February 13, 2025

Dr. Bradley Borum, Director of Research, Policy, and Planning  
Indiana Utility Regulatory Commission  
PNC Center, 101 W. Washington Street, Suite 1500E  
Indianapolis, IN 46204

**Re: Sierra Club's comments on Duke Energy Indiana's 2024 IRP**

**Figure 1: Duke's Preferred Plan (Blend 2) Additions (MW)<sup>8</sup>**

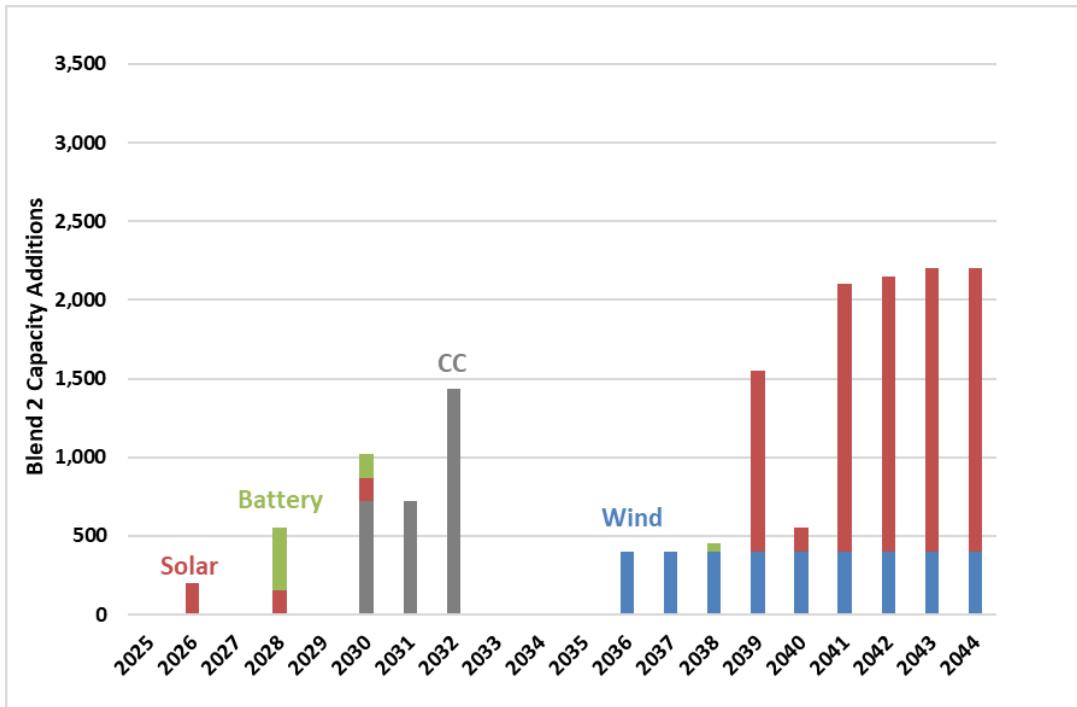
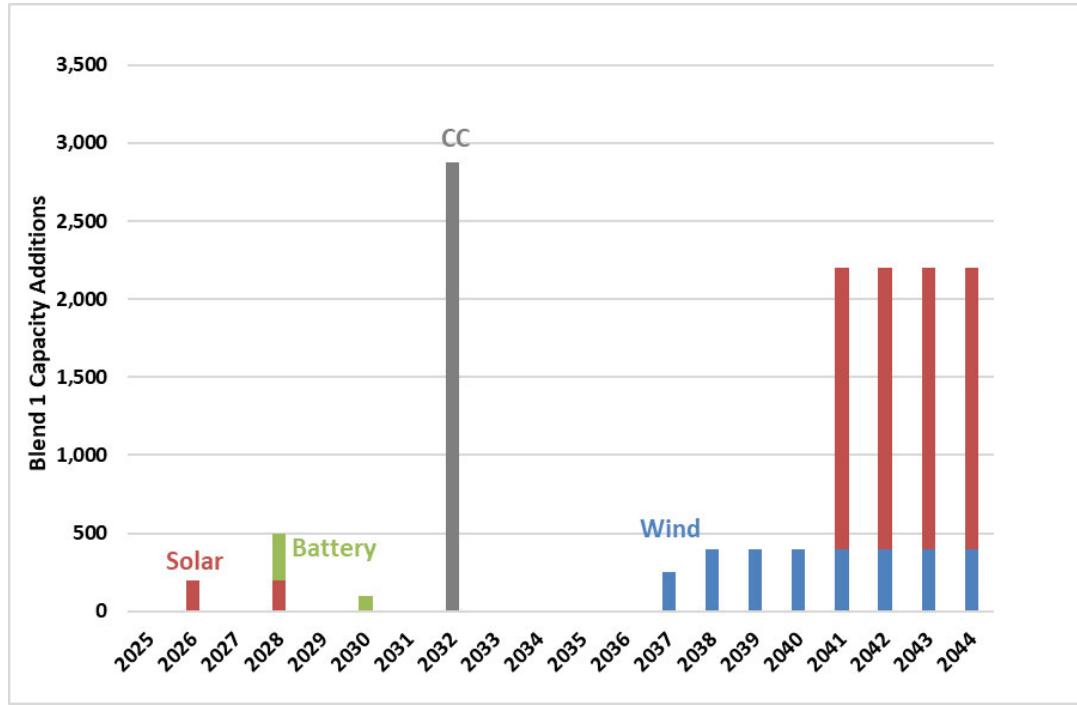
One key difference between Blend 1 and Blend 2 (Duke's preferred plan) is that Blend 1 converts Cayuga to gas and builds a new natural gas combined cycle (NGCC) in 2032, whereas Blend 2 *replaces* Cayuga with an NGCC in 2030. Figures 1 and 2 below show the comparison of new capacity additions between Blend 2 and Blend 1, respectively.

We are concerned that the Company will use the selection of the Blend 2 plan in this IRP as justification for a future Certificate of Public Convenience and Necessity (CPCN) filing for a new NGCC in 2030. Such a filing would be ill-advised given the evidence from Duke's modeling that overwhelmingly shows that reducing new NGCC investments in part by converting Cayuga rather than retiring it is favorable—as we show below. In the last section of these comments, we discuss how the Company's assumed clean resource costs unfairly handicapped them from being selected in the model's optimization. A conversion of Cayuga to gas provides more time for the additional clean replacement options in the late 2020's or early 2030's than is projected in either Blend 1 or Blend 2.

**Figure 3: Capital Revenue Requirements (\$mil) for Blend 2's NGCC in 2032<sup>13</sup>**

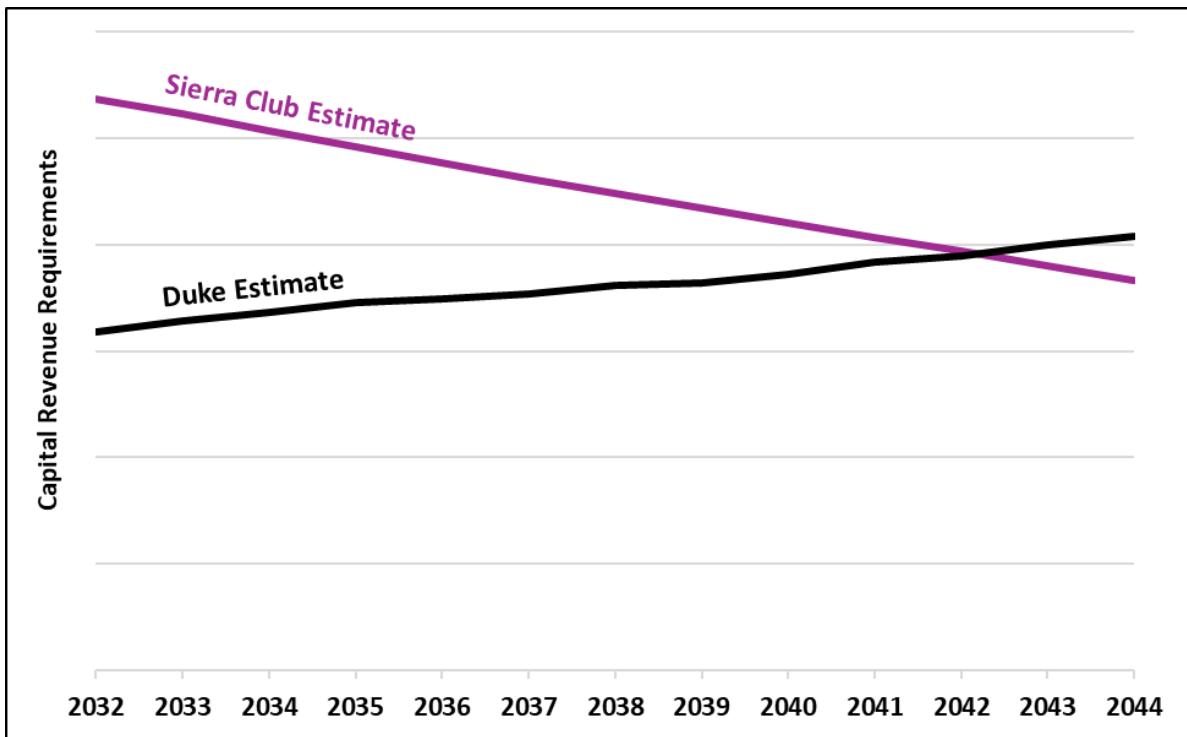
Duke’s approach understates the impact of new resources on rates in the near- and medium-term. To demonstrate this, below we show the two different approaches to calculating capital costs of the 1,200 MW NGCC being installed in 2032 for Duke’s preferred plan. Our estimate is that the rate-based approach that is more aligned with how the capital costs of the new gas plant would be charged to customers. Duke’s estimate is akin to a PPA where costs are recovered evenly but with annual escalation to account for inflation. Over the course of the plant’s life—which runs past the analysis period—the PVRR of the two approaches should be identical. But the timing of the rate recovery matters to customers and should be realistically represented in the IRP, especially for major investment decisions.

With this in mind, we recalculated the portfolio's PVRRs by using the revenue requirements directly reported in EnCompass which treat new resources as rate-based.<sup>14</sup> We then calculated the net present value of these annual costs using the Company's weighted average cost of capital (WACC) as the discount rate.

**Figure 4: Modeled Capacity Factors for Gibson Units under Blend 2<sup>31</sup>**

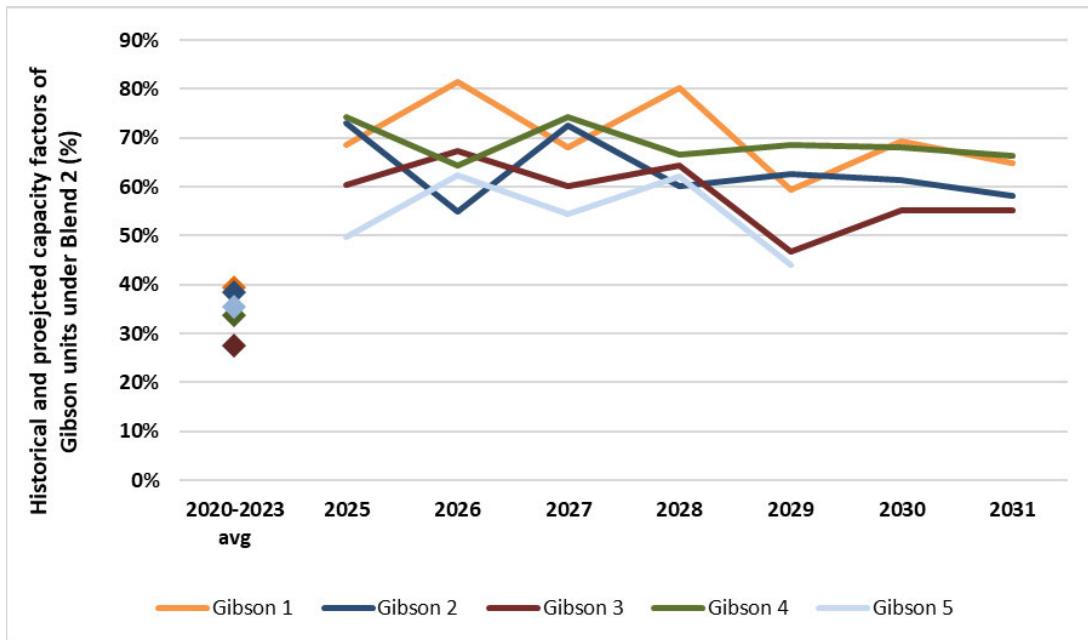
The frequency of operation—or capacity factors—at Gibson and Cayuga are well above the historical averages for the Company’s coal units. For Gibson, this is likely driven by Duke assuming that the units are more efficient, despite recent past performance that contradicts those assumptions. Figure 4 shows historical average (2020-2023) for Gibson compared to the projected capacity factors from the IRP modeling and Figure 5 shows the same data for Cayuga. The units are modeled to operate at about double their typical performance.

These drastic increases in capacity factors are likely due to the Company's modeling assuming that the units are more economically attractive than they have been recently. Primarily, we are concerned that the heat rates of the Gibson units 1 through 4 are far understated in the Company's modeling, and therefore the units are appearing much more efficient than they are in reality. Shown below in Table 6, the Gibson units in the model are on average 9 percent more efficient than they have been in recent years. We are unaware of any technical reason that all of the Gibson units would improve their efficiency to this extent. Therefore, we recommend that the Company adjust the heat rates of the Gibson units to be more in line with past performance.

We encourage the Company to model more realistic fuel costs and heat rates for Cayuga and Gibson units 1-4 in the IRP.

**Figure 5: Modeled Capacity Factors for Cayuga Units under Blend 2<sup>32</sup>**

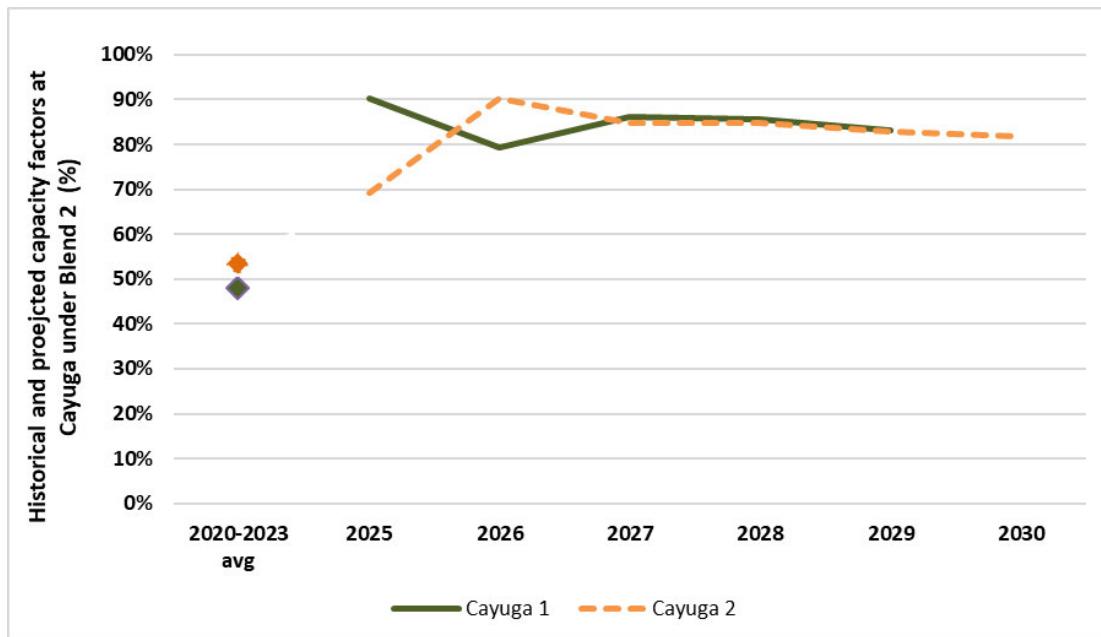
Furthermore, the Company's modeling of fuel prices (\$/MMBtu) are likely understated. We compared the fuel costs at Cayuga and Gibson units 1-4 and they appear much lower than the costs have been most recently.<sup>34</sup>

**Figure 6: Overnight capital costs for solar PV (\$/kW nominal, unsubsidized)<sup>38</sup>**

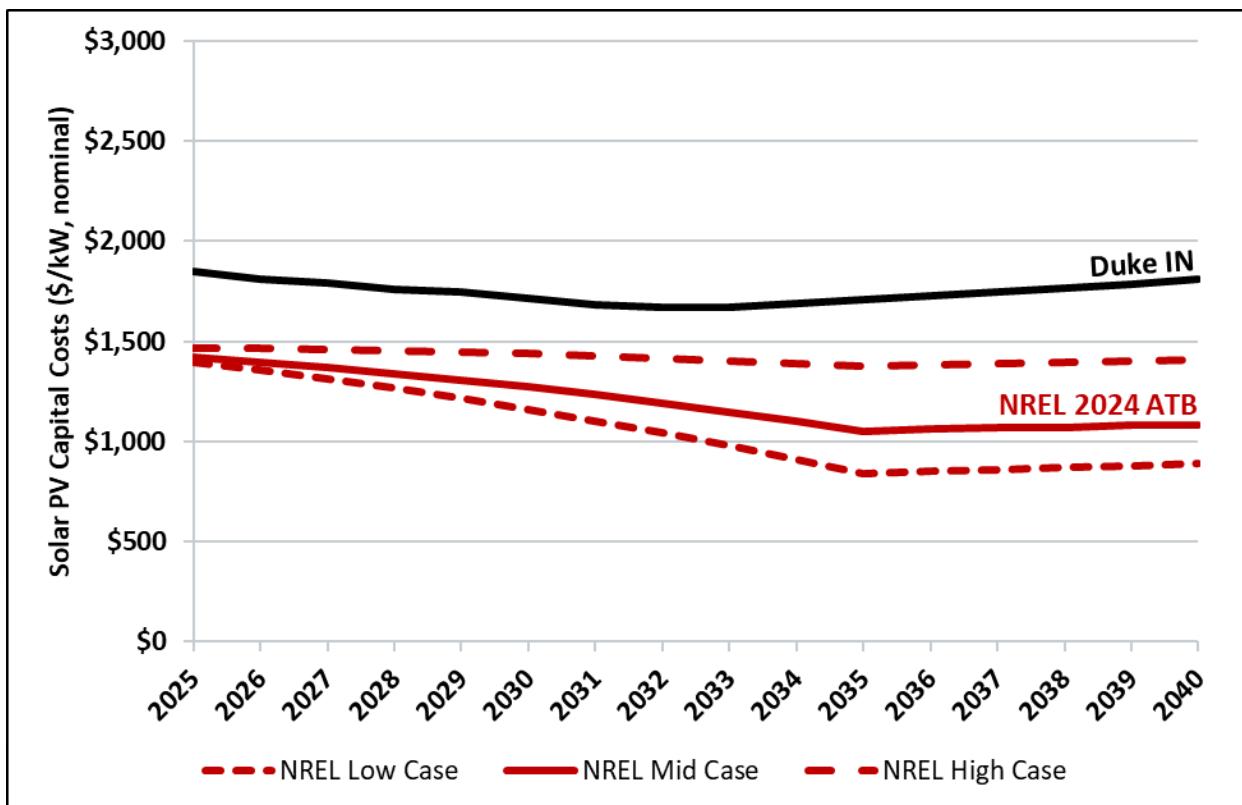
For new clean energy resources, Duke constructed long-term forecasts of capital costs using the U.S. Energy Information Administration’s (“EIA”) Annual Energy Outlook (“AEO”) data in combination with data prepared by Guidehouse for solar, wind, and storage resources.<sup>35</sup> For solar resources, Duke’s forecast sets the initial project cost at \$1,850/kW and applies nominal escalation rates (i.e., annual percent changes).<sup>36</sup> For wind resources, Duke’s forecast starts at \$2,050/kW and for battery storage resources it starts at \$2,300/kW.<sup>37</sup> We compared Duke’s forecasts with more up-to-date cost projections from the National Renewable Energy Laboratory’s (“NREL”) 2024 Annual Technology Baseline (“ATB”), including NREL’s sensitivities for low, mid, and high costs (i.e., NREL’s Advanced, Moderate, and Conservative cases, respectively). Duke’s assumed capital costs for solar and wind resources are substantially higher than those reported in NREL’s 2024 ATB—as shown below in the figures below.

The Company modeled unreasonably high costs for clean energy resources. The Company's costs of solar are roughly 35 percent higher than the NREL's mid-price forecast in 2030; Duke's wind costs are roughly 29 percent higher as well. Sierra Club understands that there were temporary, short-term cost increases due in part to interconnection delays. But there are concerted efforts across the US to mitigate this obstacle—including in PJM. It is therefore widely assumed and forecasted that the high costs of clean replacement are temporary, therefore the Company should have at least modeled a scenario or sensitivity with lower capital costs for clean energy resources.

**Figure 8: Overnight capital costs for storage (\$/kW nominal, unsubsidized)<sup>40</sup>**

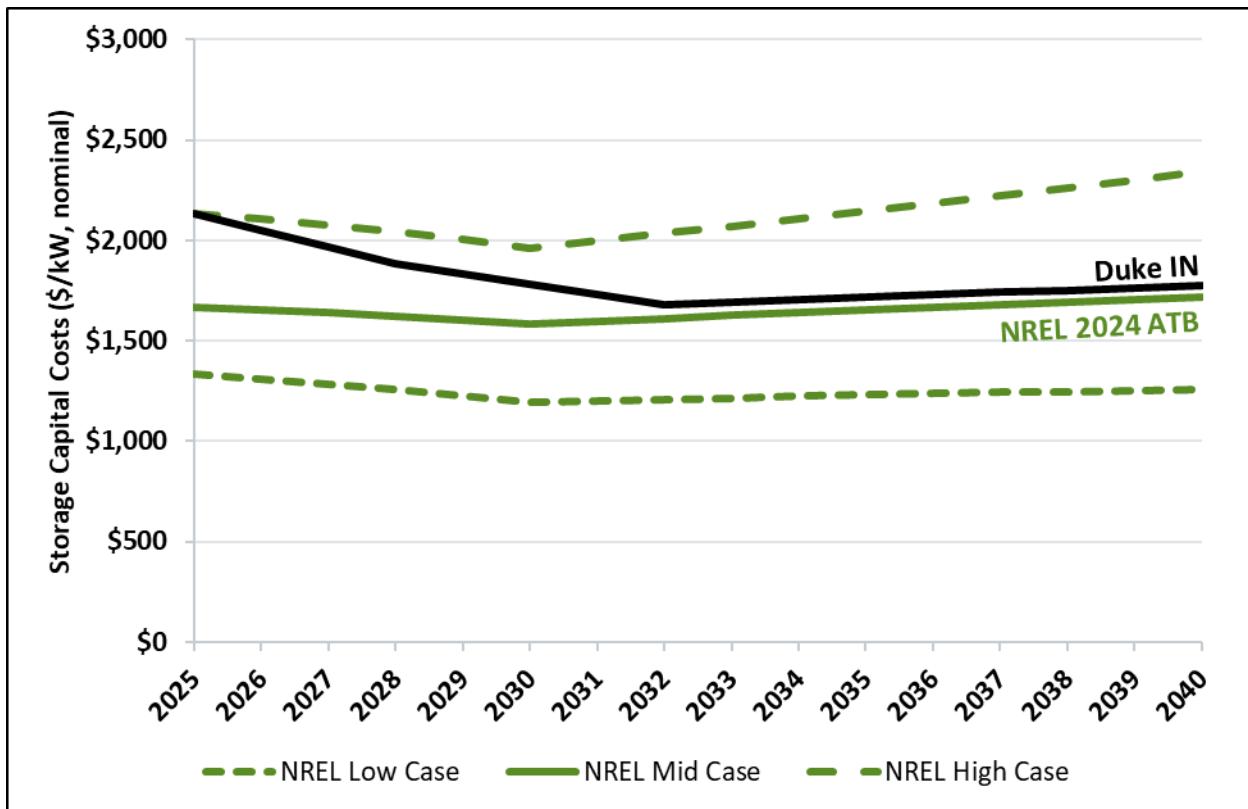
The Company's forecast for battery storage is more in-line with NREL but only starting in 2032. In the meantime, it is assuming much higher costs for this resource, as shown below in Figure 8.
